Addendum Number 3

Lake Peachtree Spillway Replacement Project

August 4, 2017

DESCRIPTION

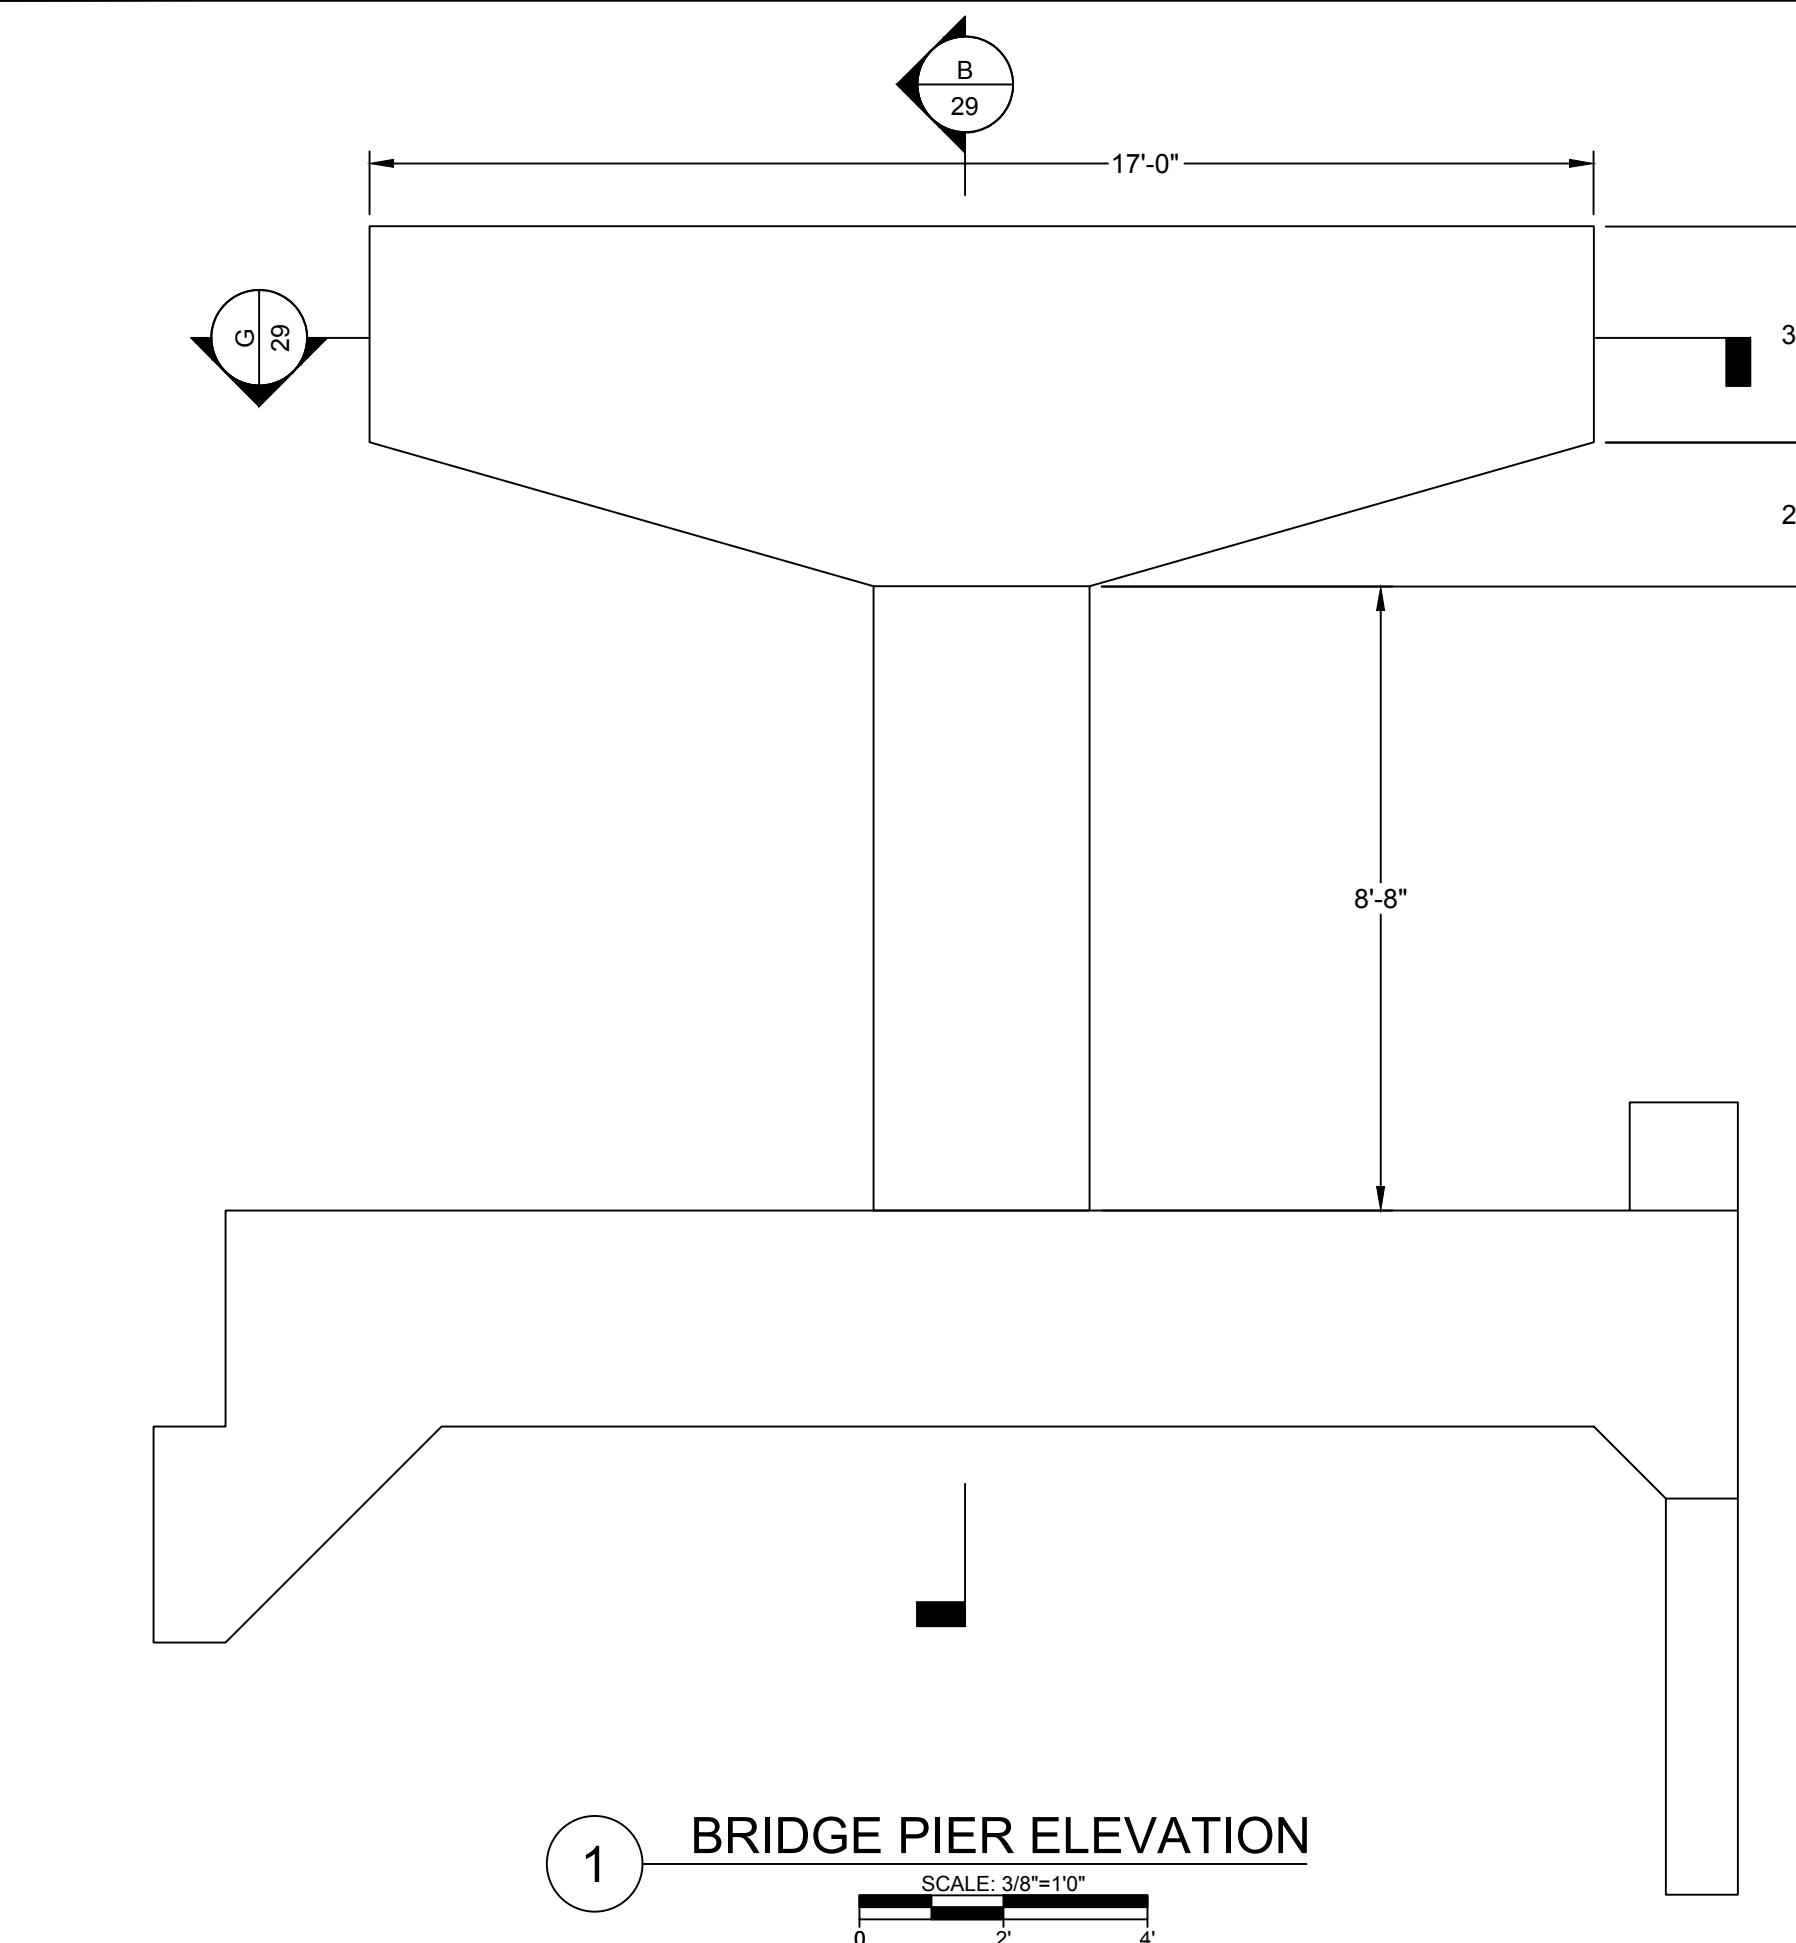
4. (Reference: Plan Sheet 29) The detail for the bridge pier elevation and section show different dimensions for the stem and the cap. Please confirm that the dimensions shown on the section details are correct.

- a. The dimensions shown on the section view are correct. An updated sheet depicting the bridge dimensions is appended for your convenience.
5. (Reference: Plan Sheets 33, 40, 43, 44) Please provide depths for the upper cut-off walls for slab sections G1, G2, H1, H2 and I1. Also provide rebar configurations for these walls.

NOTE: PROVIDE ADDITIONAL #4 @ 12" O.C. EACH FACE, EACH WAY IN A 10 FOOT BY 10 FOOT GRID CENTERED AROUND THE BRIDGE PIER.

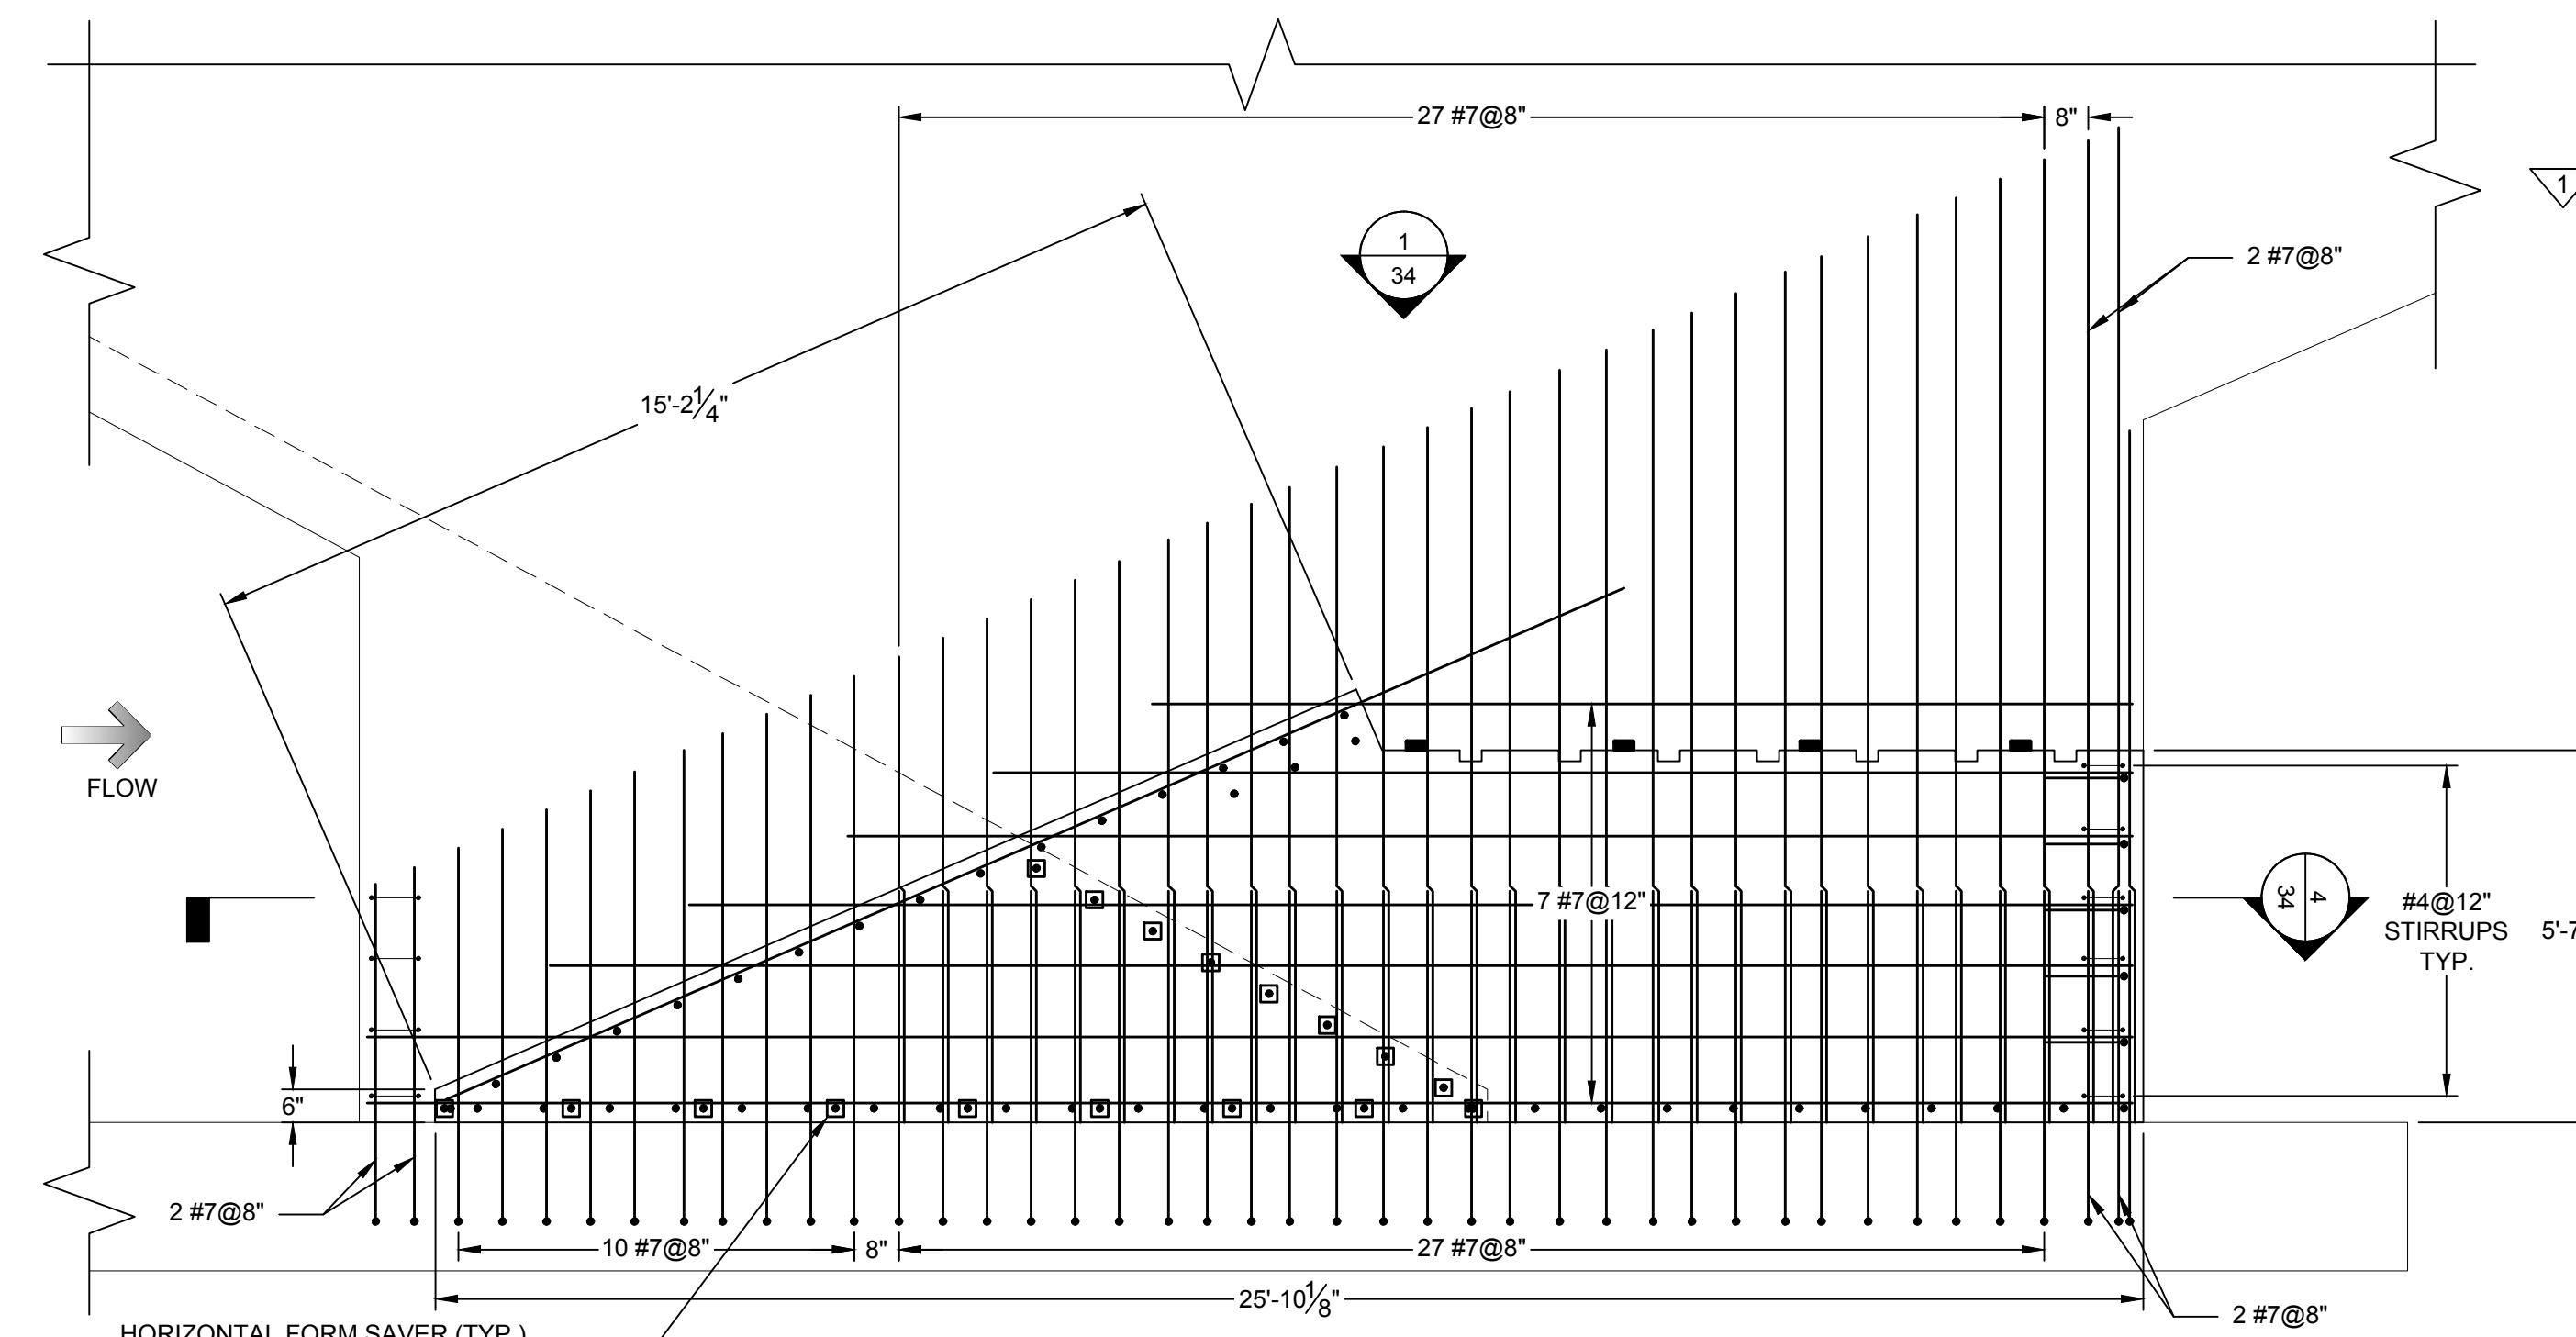
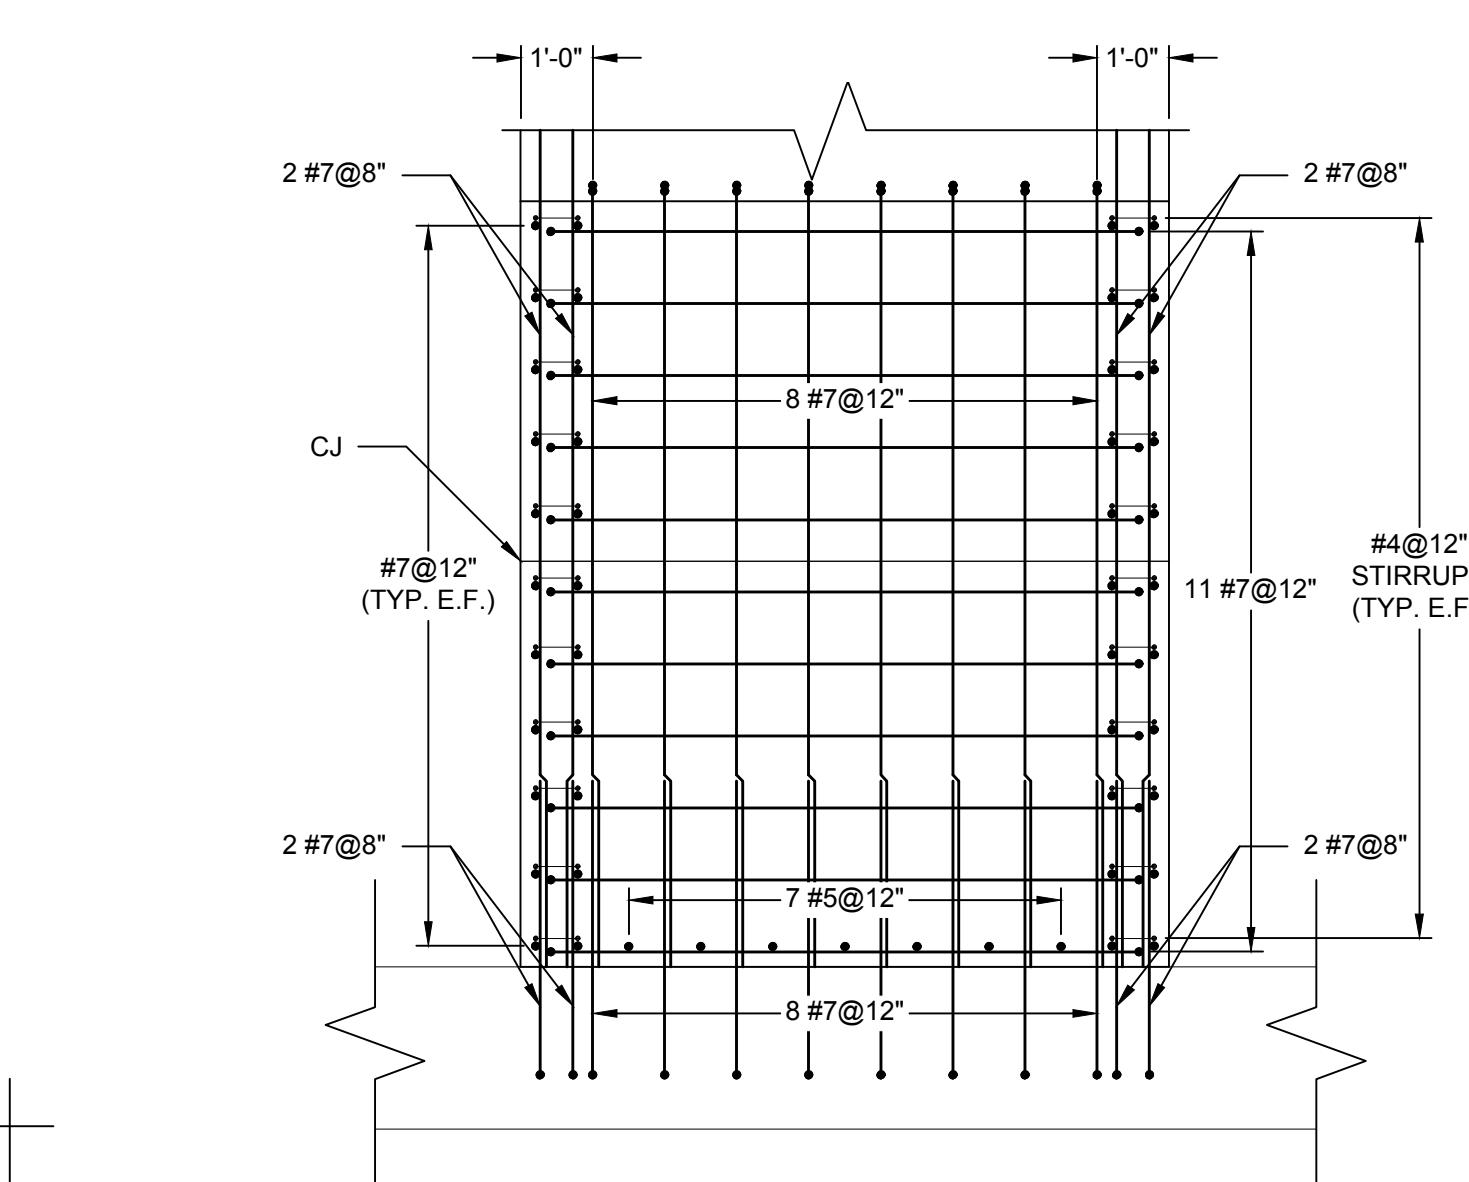
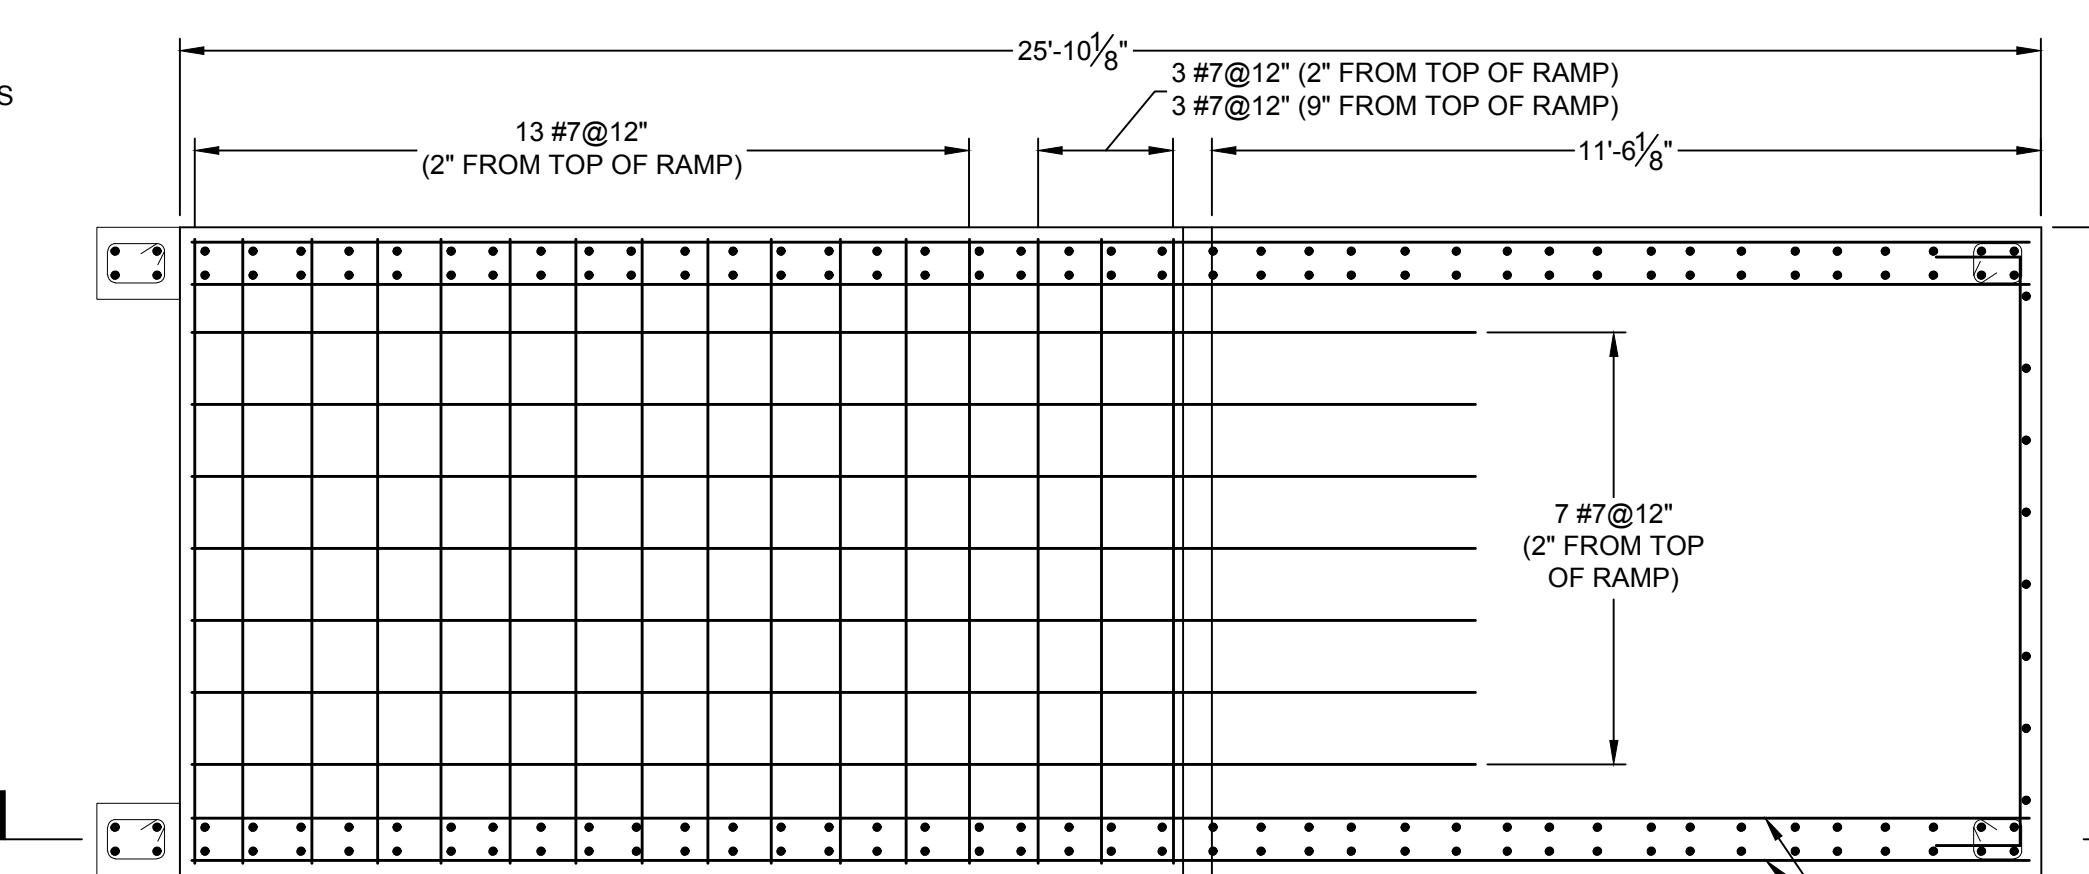
Note: Additional temperature and shrinkage reinforcing steel was added in the ramp/infill sections of the piano key weirs. Sheets with material changes were noted as Revised per Addendum No. 3. Sheets that were inadvertently affected by the changes are included, but do not contain revision clouds/call-outs. The additional reinforcing typically includes the addition of #5@12" spacing, #7@12" spacing, and #4@24" spacing depending on the specific locations of reinforcing.
